SERVICE DIRECTIVE BULLETIN NO. 0126

Revision 1

DATE: July 6, 2023

1. SUBJECT: Cabin Bellcrank Mounts and Bellcrank Attachment Inspection
2. MODEL: F-28A, 280, F-28C, F-28C-2, F-28C-2R, 280C, F-28F, F-28F-R, 280F, and 280FX
3. EFFECTIVITY: All S/N (Note special exclusion in paragraph 5.3.)

Figure 4. Upper Cabin Mount Inspection (LH Shown)

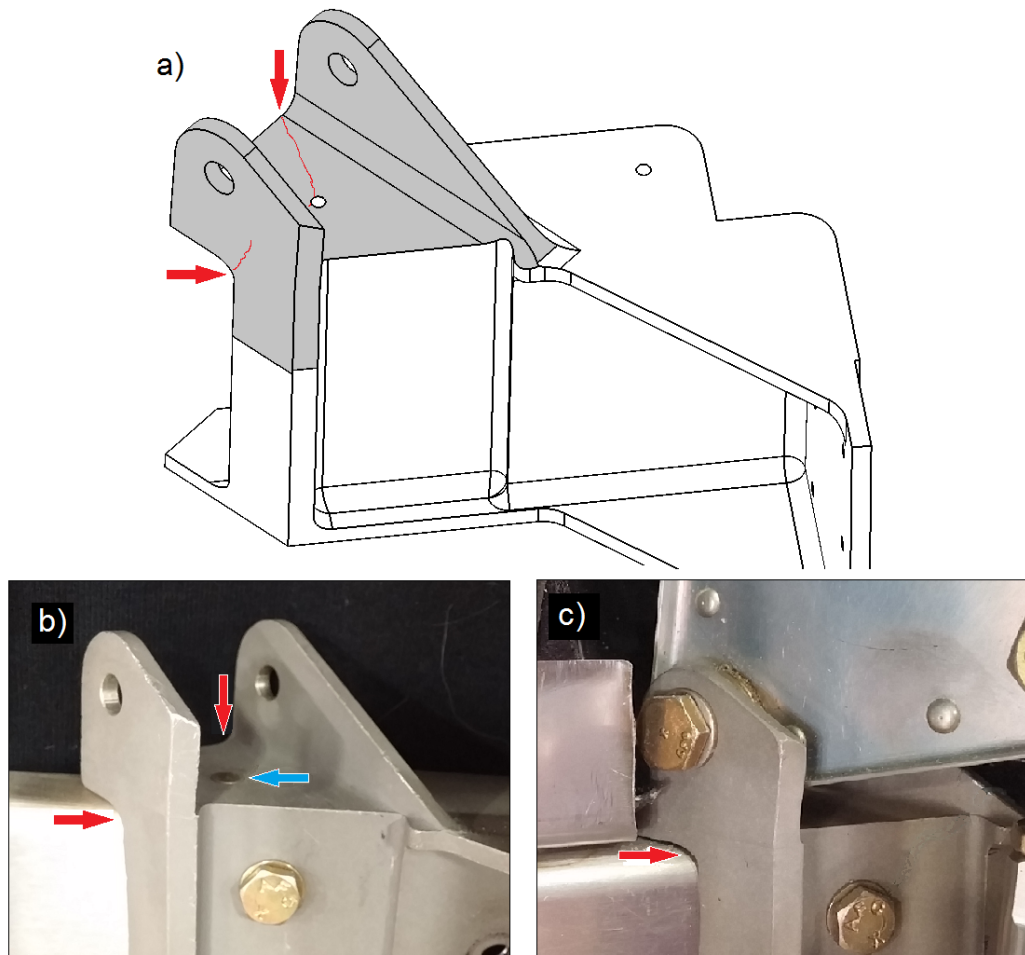
- 6.1.7 Inspect the cabin mount for cracks using dye penetrant method. Follow the manufacturer's instructions. Refer to Figure 4 for the area to inspect.
- 6.1.7.1 Positive indication – Reject the cabin mount and replace with an airworthy cabin mount. Contact Enstrom Product Support for the replacement procedure.
- 6.1.8 If no indication, remove the dye products from the area per the manufacturer's instructions and inspect all visible rivets (countersunk and universal head) for condition and looseness. Replace loose rivets, as necessary.
- 6.1.9 Repeat 6.1.3 through 6.1.8 for the opposite side cabin mount or proceed to step 6.3.

- 6.2.3 Use a solvent (denatured alcohol, mineral spirits, or equivalent) to remove grease or oil residue from the cabin mount.
 - 6.2.4 With a bright light source and inspection mirror, visually inspect the cabin mounts for cracks, particularly in the area indicated in Figure 4-c.

- 6.2.4.1 If a crack is detected, reject the cabin mount and replace with an airworthy cabin mount. Contact Enstrom Product Support for the replacement procedure.

- 6.2.5 If no crack is detected, inspect all visible rivets (countersunk and universal head) for condition and looseness. Replace loose rivets, as necessary.

Figure 5. Hardware Stack-up Calculation

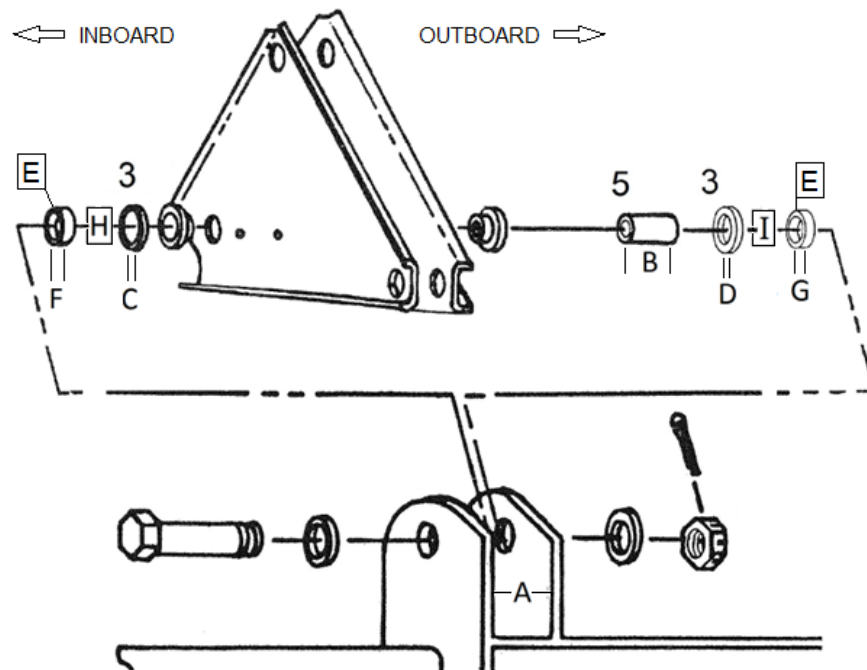
This procedure compares the measurement between the cabin mount ears and the calculated length of the hardware stack-up. Any deficiency in hardware stack-up is corrected by installing spacer P/N 28-16209-x (if required) and shim P/N 28-16217-x as required.

- 6.4 Hardware stack-up for the LH cabin mount. See Figure 5.
 - 6.4.1 Measure the distance between the 0.250 inch diameter holes of P/N 28-11307-1 mount. This is Measurement A.

- 6.4.2 Measure the length of spacer (Item 5). This is Measurement B.
 - 6.4.3 Measure the thickness of washer (Item 3, inboard). This is Measurement C.

- 6.4.4 Measure the thickness of washer (Item 3, outboard). This is Measurement D.
 - 6.4.5 Solve for Δ using this formula: $A - (B + C + D) = \Delta$
 - 6.4.6 Determine spacer (Item 4) selection from this formula: $\Delta / 2 = E$

- 6.4.6.1 Select spacer P/N 28-16209-1 if E value is ≥ 0.101 inch.
 - 6.4.6.2 Select spacer P/N 28-16209-11 if E value is ≤ 0.100 inch.
 - 6.4.7 Measure the thickness of spacer (Item 4, inboard). This is Measurement F.

- 6.4.8 Measure the thickness of spacer (Item 4, outboard). This is Measurement G.
 - 6.4.9 Determine the shim thickness required for the inboard side. This will be Measurement H.

- 6.4.9.1 Solve for H using this formula: $E - F = H$
 - 6.4.9.2 Select P/N 28-16217-x as required to equal H.
 - 6.4.10 Determine the shim thickness required for the outboard side. This will be Measurement I.

- 6.4.10.1 Solve for I using this formula: $E - G = I$
 - 6.4.10.2 Select P/N 28-16217-x as required to equal I.
 - 6.4.11 Verify that $(B + C + D + F + G + H + I) = A (+0/-0.001)$

- 6.4.12 Install P/N 28-16217-x (Item 16) shims, as required, between Item 3 and Item 4, inboard and outboard, respectively.
- 6.5 Torque (50-70 in-lb/5.6-7.9 Nm) and safety the nut.
- 6.6 Repeat steps 6.4 and 6.5 for the RH cabin mount.
- 6.7 Reinstall the control tube covers, if installed.
 - 6.7.1 Reinstall the four cover fasteners.
 - 6.7.2 Reposition the boot and secure with cable ties.
 - 6.7.3 Seal the cover edge with RTV sealant (Dow Corning 732, or equivalent).
- 6.8 Reinstall the fuel tanks.
- 6.9 Reinstall the seat structure cover.
